Site Plan and Design Review
Staff Report and Recommendation

Community Development Department, Planning Division

REPORT DATE:	November 30, 2020
HEARING DATE:	December 7, 2020
LAND USE REQUEST:	Site plan approval and design review of a proposed 3-building 15-unit townhome complex
FILE NUMBER:	311-20-000163-PLNG
PROJECT NAME:	None
PROPERTY LOCATION:	2828 22nd Avenue
LEGAL DESCRIPTION:	Washington County Tax Lot 1N331DD01700
APPLICANT/OWNER:	State Street Homes 1233 NW Northrup Street #125 Portland, Oregon 97209
COMPREHENSIVE PLAN MAP DESIGNATION:	High Density Residential (HDR)
ZONING MAP DESIGNATION:	Residential Multi-Unit High Density (RMH)
APPLICABLE STANDARDS AND CRITERIA:	City of Forest Grove Development Code §17.2.300 et. seq. *Design Review* §17.2.400 et. seq. *Site Development Review* §17.3.100 - .140 *Residential Zones* §17.5.130 *Trees on Developable Land* §17.7.040 *Fence Standards* §17.7.200 et. seq. *Solid Waste and Recycling* §17.8.000 et. seq. *General Development Standards* City of Forest Grove Design Guideline Handbook Focus Area III *Multi-Unit Residential Focus Area*

REVIEWING STAFF:	James Reitz (AICP) Senior Planner
RECOMMENDATION:	Staff recommends approval with co

Site Plan (North ←)

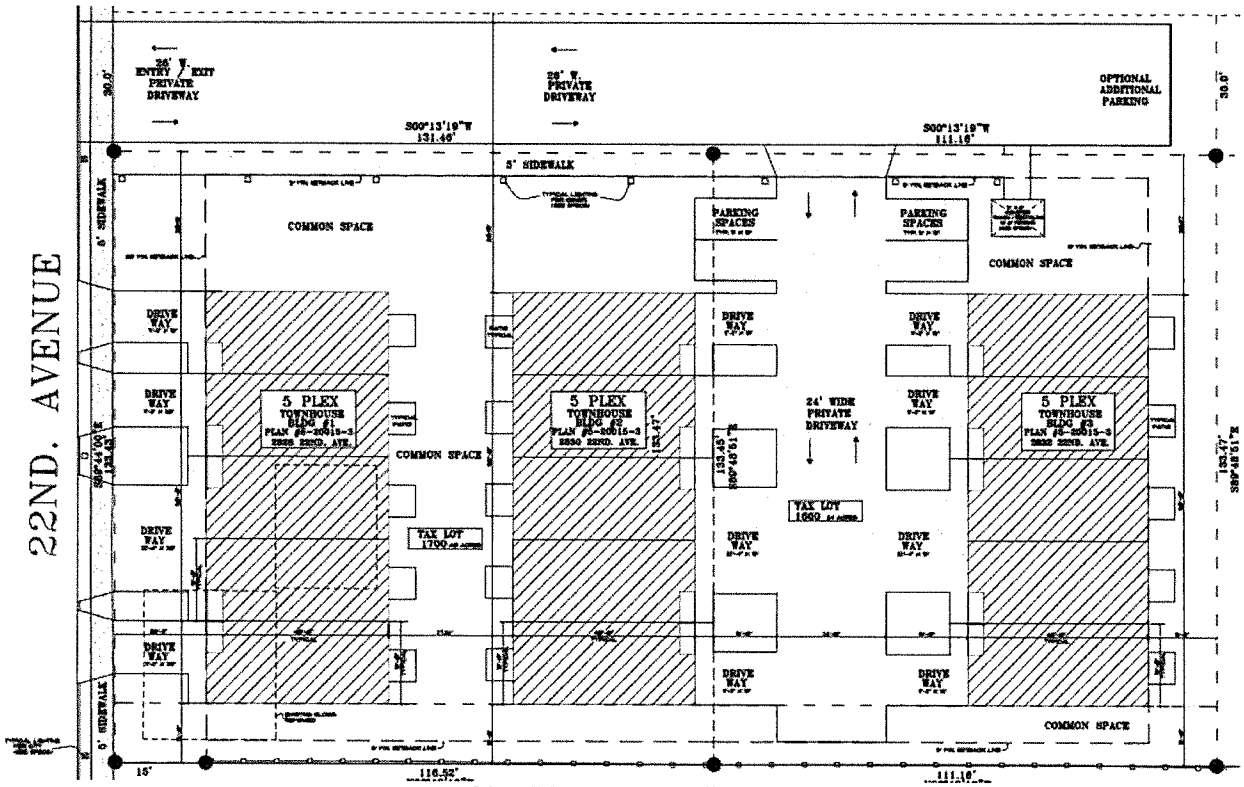
- A sidewalk is present along 22nd Avenue.
   - The north building would have no walkways connecting to the 22nd Avenue sidewalk; residents and visitors would have to use the driveways. DC §17.8.140(A)(1) requires a separate walkway connection. This could be accomplished by installing a walkway adjacent to the driveway using a different paving material. This stipulation has been included in the Development Code conditions listed in Exhibit C.

- A 5-foot-wide concrete pedestrian walkway is proposed along the west side of Kappel Lane. It will need to be extended to the south property line of the project site so that it may be continued when the adjoining properties redevelop (DC §17.8.140(A)(1)). This stipulation has been included in the Development Code conditions listed in Exhibit C.

- No walkways are proposed that would connect the central and south buildings with the Kappel Lane walkway, as required by DC §17.8.140(A)(1). While it would be possible to install a walkway abutting each building, that location would compromise resident's privacy. In the alternative, the walkways could abut the drive aisle. In both instances, the central building would need to be shifted northward in order to provide sufficient space, thus reducing the yard width between the north and central buildings. Because the driveway would serve only 10 units and would be a dead end, the Planning Commission may want to consider an alternative approach as discussed under the Design Guidelines section below.

Staff has included an **optional condition** to construct the driveway as a shared travel-way and pedestrian zone.

(1) Different paving (2) Signage (3) Landscaping (4) Lighting (5) Low-speed travel-way

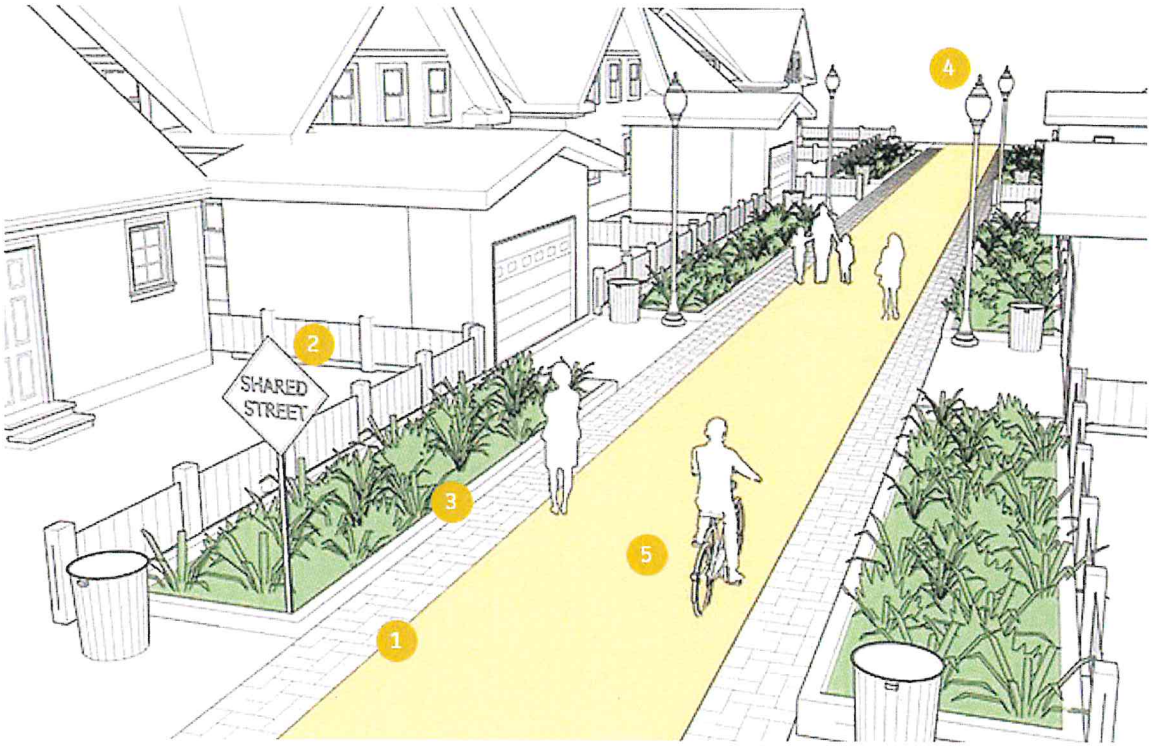
Because the driveway would serve only 10 units and would be a dead end, the Planning Commission may want to consider waiving the walkway requirement on both sides of the driveway in favor of a "shared alley" concept, illustrated below.

Such a shared driveway/pedestrian space would comply with this recommended Design Guideline*: "Provide comprehensive, pleasant and direct pedestrian pathways linking buildings, open space and parking areas."* As proposed, the driveway has already been designed as a low-speed travel-way with landscaping elements; and because it would serve only 10 units and would be a dead-end, signage is probably not necessary. Only some paving differentiation and pedestrian-scale lighting would be needed.
